Draft of IEC 60512-99-002

Catania - October 2015

IEC 60512-99-002: Test Current

48B/2438/CD (60512-99-002) 5.2 Voltage and current

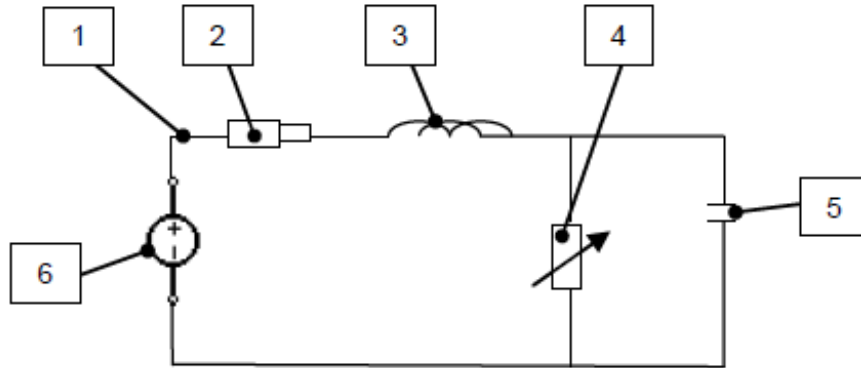
- › **Max. 1 A assumed as worst case**
- › **Discussion (48B/WG5 23.9.2015 Prague):
Worst case in 4-pair systems → 2 A?**
(If no independent power sources for the pairs)

IEEE 802.3 bt specifies a maximum current of 0,5 A per conductor and an open circuit voltage of 55 V dc. The test current has been doubled to 1,0 A in order to represent the high probability that one contact of any given pair will separate before the other. Therefore, as in the cited application, the pairs form individual parallel circuits, the last to break will do so carrying all the current, (twice the nominal).

48B/2438/CD (60512-99-002)

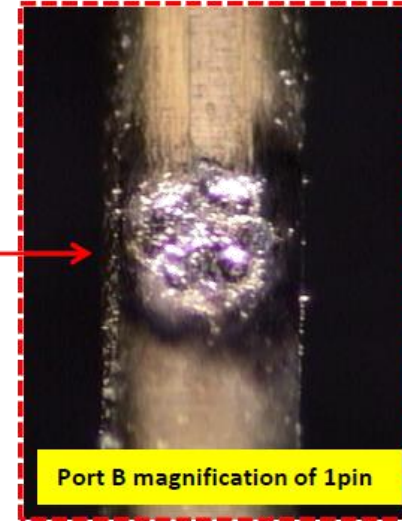
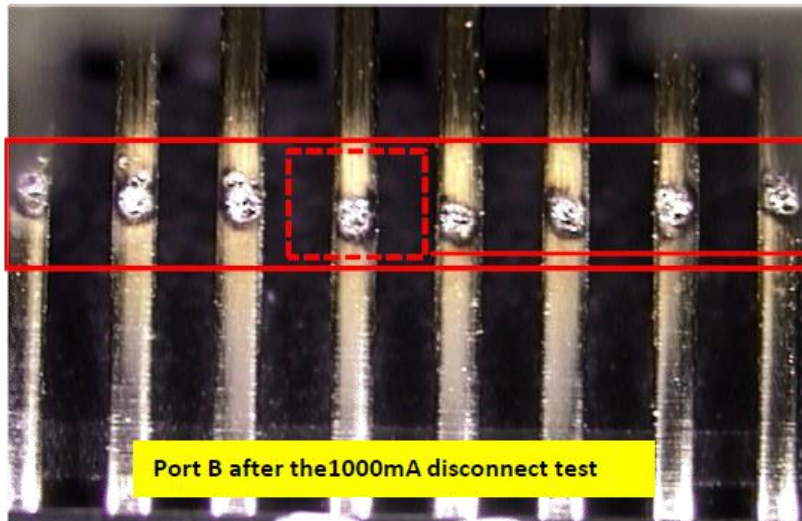
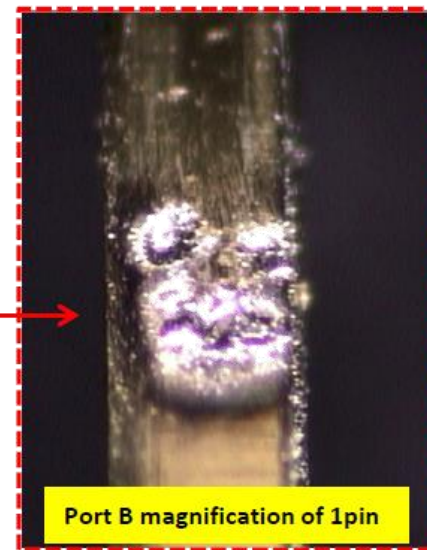
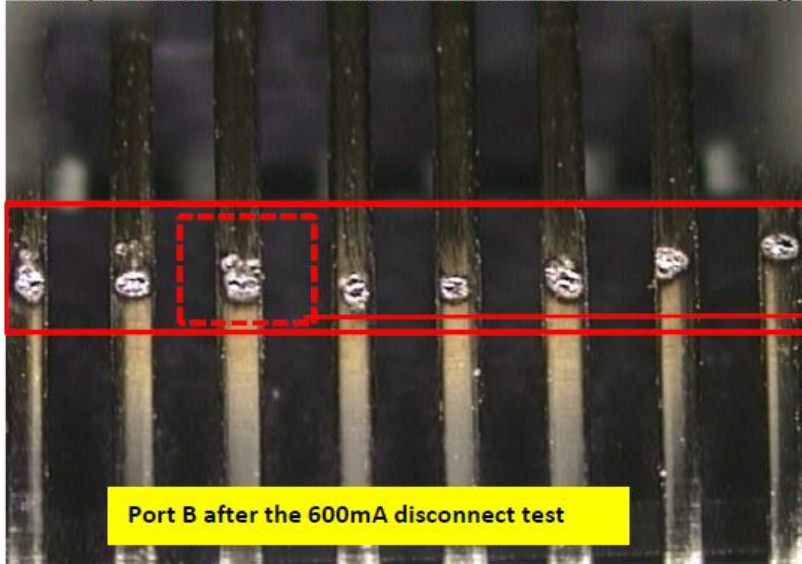
Significant higher damages reported with this test circuit compared with disconnect tests with real 4P-PoE circuit !

(PSE-PD Evaluation system with 90Watt /Type 4 (850mA /pair) 1m cable)

- › **Only few cycles expected:
Does this suit to future high power
PoE applications?**

RJ-45 Jack / 600mA vs. 1A

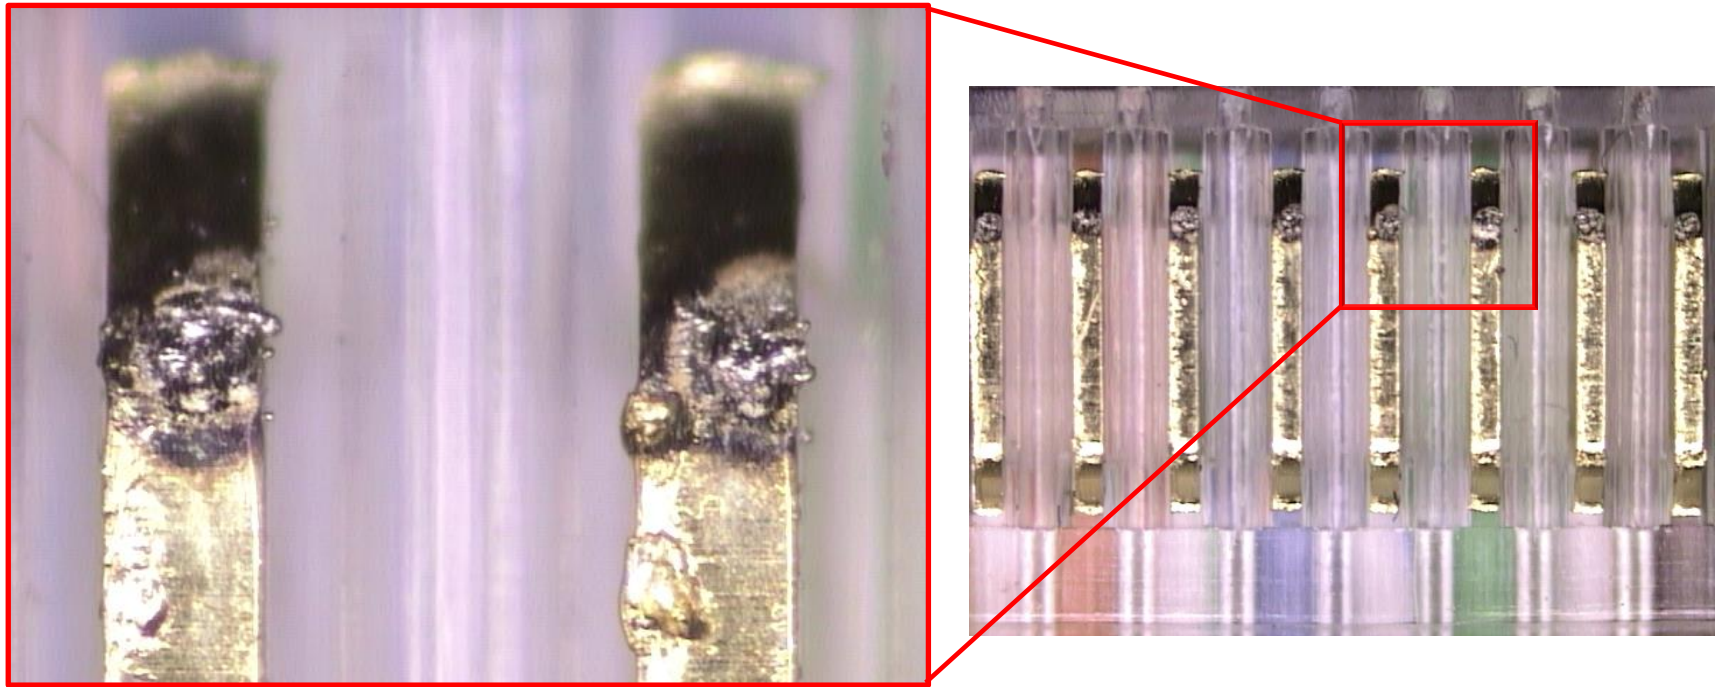
RJ45 port contact condition after 600mA / 1000mA testing:

30 cycles / without aging

- › **Visual damages similar between 600mA and 1A (30 cycles / IEC test circuit only)**
 - › **Contact resistance not affected without aging* also after 750 cycles**
 - › **Resistance increase up to **114mΩ** reported after 750 cycles (1A) and aging* (no full FMG)!**
- **Unbalance calculations affected?**
